Re: Docket No. E-00000D-03-0047

**WELLTON-MOHAWK
GENERATING FACILITY'S
PRELIMINARY ASSESSMENT OF
PROJECT IMPACTS ON RMR
REQUIREMENTS FOR THE YUMA AREA**

March 6, 2003

Prepared by Navigant Consulting, Inc.
201 E. Washington Street
Collier Center, Suite 1750
Phoenix, AZ 85004

FIGURE 2
YUMA RMR REQUIREMENTS - WITHOUT WMGF

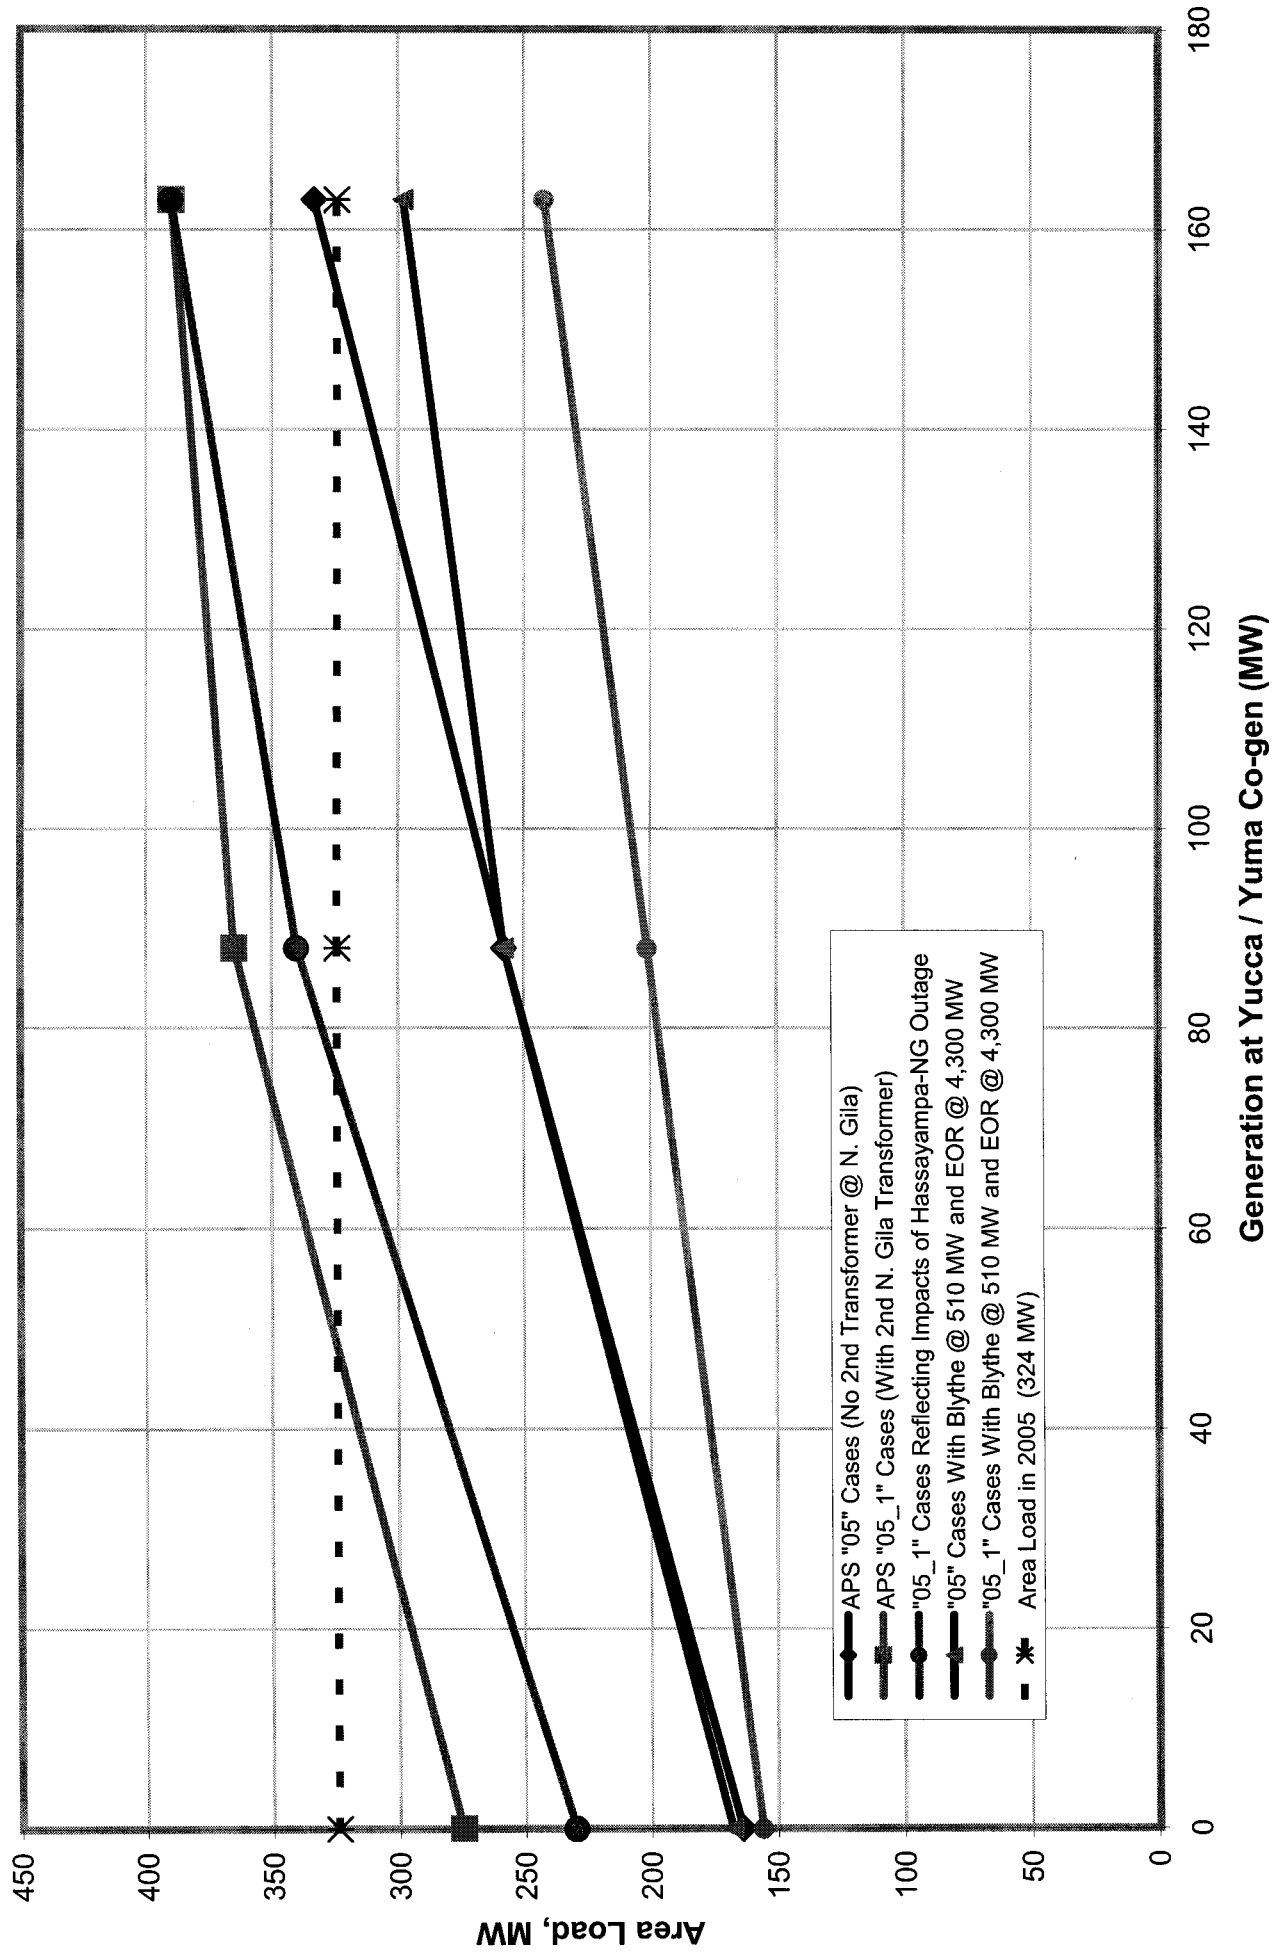
The information in Table 2 and Figure 2 shows that:

1. The amounts of RMR generation required from the existing generation without a second transformer at North Gila increases from 0 MW at minimum load to slightly over 160 MW during peak load periods. The System Import Limit

(SIL) increases from 164 MW at minimum load to 170 MW at the other two load levels studied.

2. Adding the second North Gila 500/69-kV transformer would increase the SIL to 275 MW at minimum load and to 390 MW at peak load if the Hassayampa-North Gila line outage is not considered. The increased SILs decrease the existing generation RMR requirement at the 2005 peak load level to about 50 MW (refer to Figure 2).

3. If the impacts of the Hassayampa-North Gila line outage are considered, the SIL would decrease to 230 MW at minimum load and to 252 MW when loads are at about 77% of peak. With these decreased SILs the existing generation RMR requirement at the 2005 peak load is about 80 MW (refer to Figure 2).

4. If the Blythe Project generation is increased to 510 MW and EOR power transfers are increased to about 4,300 MW the SILs at minimum load (and resultant RMR requirement from existing generation) are about the same as in the APS cases. However, above this load level the impacts of the Hassayampa-North Gila outage become much more critical and result in overloads on the Gila 161/69-kV transformers. Because the Gila transformers feed 69-kV lines into the APS Area and serve Western load, the NCI studies assumed that both would be reduced on a pro-rata basis as required to mitigate overloads on the Gila transformers. Without the second transformer at North Gila, the resultant SILs range from 170 MW (at 77% of peak load) to 135 MW (at peak load). Because of the decreases in SIL, about 200 MW of RMR generation would be required from the existing Yuma area resources to reliably serve peak loads without the second North Gila transformer.

5. The addition of a second transformer at North Gila reduces the impedance between the North Gila 500 and 69-kV busses which, in turn, causes the flows through and overloads of the Gila transformers after the 500-kV line outage to be higher than those seen without the second transformer. Therefore, with the second transformer, the amount of load that can be served at a given generation level decreases such that the SILs are 113 MW (at 77% of peak load) and 79 MW (at peak load). The result is that about 250 MW of RMR generation is required from the existing Yuma area resources at peak loads.

FIGURE 3 YUMA RMR REQUIREMENTS - WITH WMGF

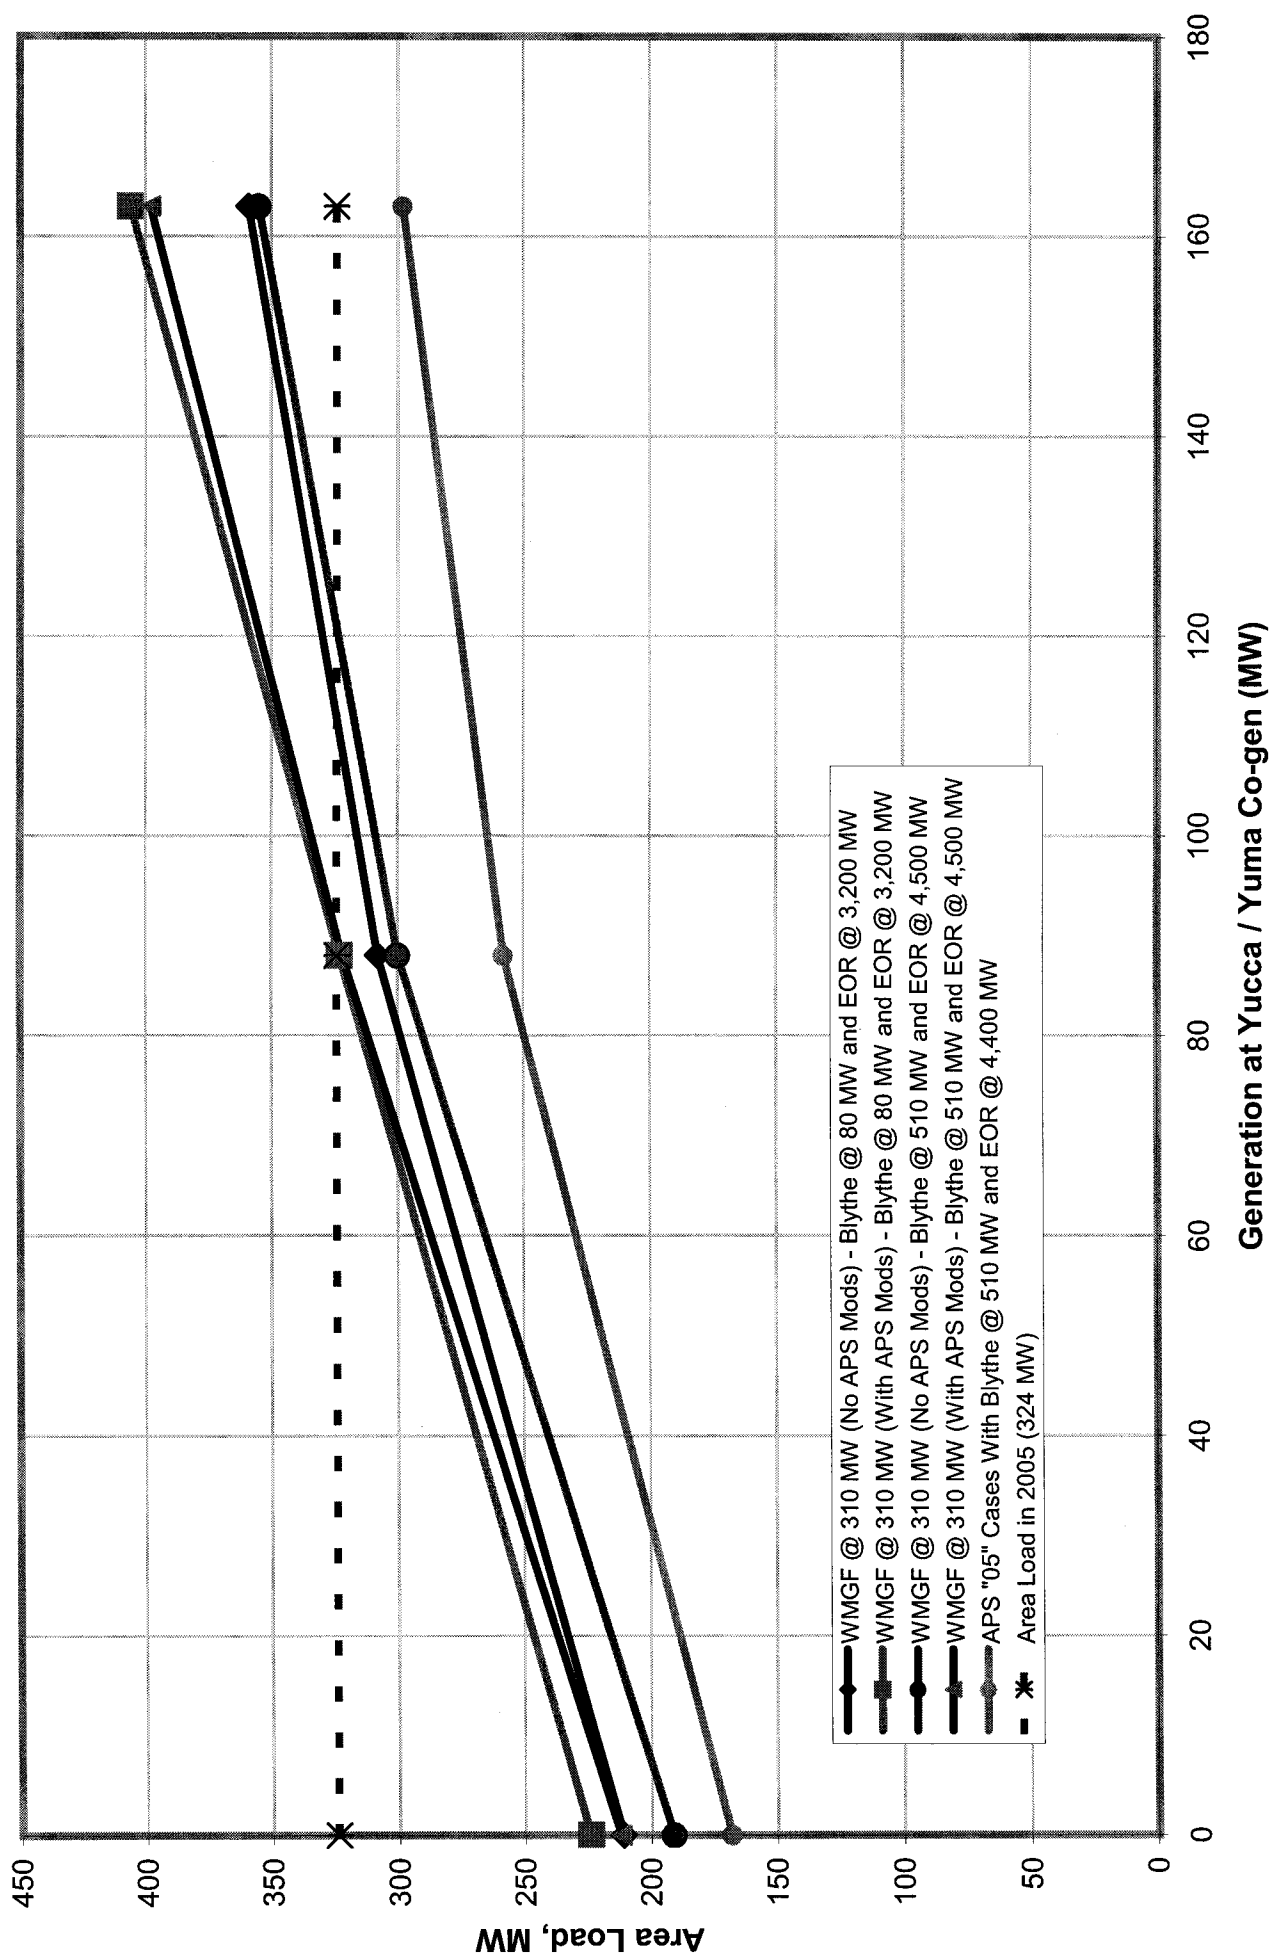
The information in Table 3 and Figure 3 shows that:

1. The SILs at minimum load range from 191 MW to 224 MW while those at peak load range from 192 MW to 243 MW (these ranges are the result of variations in the levels of Blythe Project generation and EOR transfers and on whether or not modifications are made to the APS 69-kV system). At peak load levels these amounts are higher than was the case without the WMGF on-line and mean that the same amounts of load could be served without as much reliance on the existing generation in the Area. Specifically, without any modifications to the APS system the SILs at peak load are 26 MW to 57 MW higher than was the case without the WMGF. With the specified modifications to the APS system the SILs are from 16 MW to 156 MW higher.

2. As can be seen from Figure 3, the RMR requirement from existing generation at peak loads varies depending on Blythe Project generation levels, EOR power transfers, and whether the Foothill-Foothill Tap and 32nd Street-Ivalon 69-kV lines were reconducted and the North Gila 69-kV bus was sectionalized. Without any modifications to the APS system the RMR requirement from existing generation ranges from 115-120 MW. With the specified modifications to the APS system the RMR requirement would be about 90 MW. As noted above, the RMR generation required from existing generation

in the Area without the WMGF on line would be 210 MW to 250 MW (depending on whether a second transformer is installed at North Gila)

3. If the RMR generation from existing resources was at the 163 MW level (as identified in the APS studies) the total Area load that could be served would be approximately 350 MW (without any modifications to the APS system) and about 400 MW if the modifications discussed above were made.
